UNITED STATES PATENT AND TRADEMARK OFFICE

APPLICATION NO.	FILING DATE	FIRST NAMED INVENTOR	ATTORNEY DOCKET NO.	CONFIRMATION NO.
10/720,173	11/25/2003	Eun-Bong Han	102-1003	4330

Office Action Summary

DETAILED ACTION

FIG. 1
(PRIOR ART)

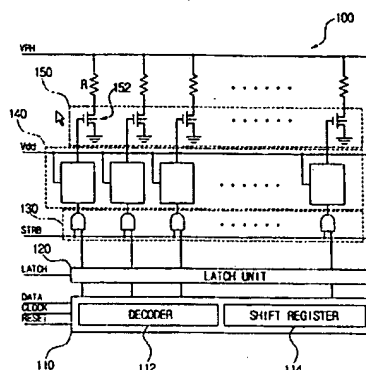
- {claim 1} An inkjet printer head driving apparatus having a plurality of heating elements and nozzles (figure 1, reference 100); a switching unit turning on and off each of the heating elements to heat ink corresponding to selected nozzles to eject the ink (figure 1, reference 150); a level shift unit having a level converter converting a potential level of a signal inputted therein into a predetermined potential level to drive the switching unit, and a transient time extending part provided with at least one time extending element to extend by a predetermined time a transient time during which the potential level of the signal inputted from the level converter to the switching unit is converted from a first signal level to a second signal level and vice versa (figure 1-2, reference 140); a control unit receiving an external data signal, decoding the received data signal, and outputting the decoded data signal as a nozzle selection signal to the level shift

unit to select the selected nozzles corresponding to a to-be-recorded image from the nozzles (figure 1, reference 110)

- {claim 8} An inkjet printer head driving apparatus having a plurality of heating elements and nozzles (figure 1, reference 100); a control unit generating a control nozzle selection signal to select a heating element and a nozzle corresponding to an image to be printed (figure 1, reference 110); a level shift unit generating a first nozzle selection signal having a first transient time, during which a level of the first nozzle selection signal is changed between first and second levels, in response to the control nozzle selection signal, and generating a second nozzle selection signal having a second transient time extended by a period from the first transient time (figure 1-2, reference 140); and a switching unit turning on and off the heating element according to the second nozzle selection signal (figure 1, reference 150)

- {claim 31} An inkjet head driving unit (figure 1); a control unit to generate a nozzle selection signal to select a nozzle having a heating element (figure 1, reference 110); a level shift unit to convert the nozzle selection signal to have a predetermined level to drive the heating element between a logic high and a logic low and having one or more logic units to increase a time required to change an output thereof between the logic high and the logic low (figure 1-2, reference 140); and a switching unit to turn the heating element on and off according to the output of the level shift unit (figure 1, reference 150)

The applicant is correct about the function of the delay of level converter 142, in itself. However, what the applicant overlooks is that the function of level converter 142 must be viewed in the context of the additional logic found in buffer 144. It is level converter 142 and buffer 144 operating in conjunction, which forms level shift unit 140. Rather than argue the applicant's arguments from the perspective of the delay of level converter 142, it might be more helpful to compare the logic in buffer 144 with the logic found in applicant's transient time extending part 243. In figure 6, the applicant has divided transient time extending part 243 into a left part (first inverter 244) and a right part (second inverter 245). The second inverter 245 consists of first PMOS 245a, second PMOS 245b, first NMOS 245c, second NMOS 245d. The applicant will appreciate that the left part of buffer 144 of the applicant's admitted prior art is identical to the first inverter 244 of figure 6. Therefore, what needs to be compared is the right part of buffer 144 with second inverter 245. Although the right part of buffer 144 does not disclose a second PMOS and second NMOS, it does disclose a first PMOS and first NMOS. What this means is that figure 2 does perform some function of extending transient time, although the extent of this function may be minimal or even negligent when compared to the time extending characteristics of transient time extending part 243.
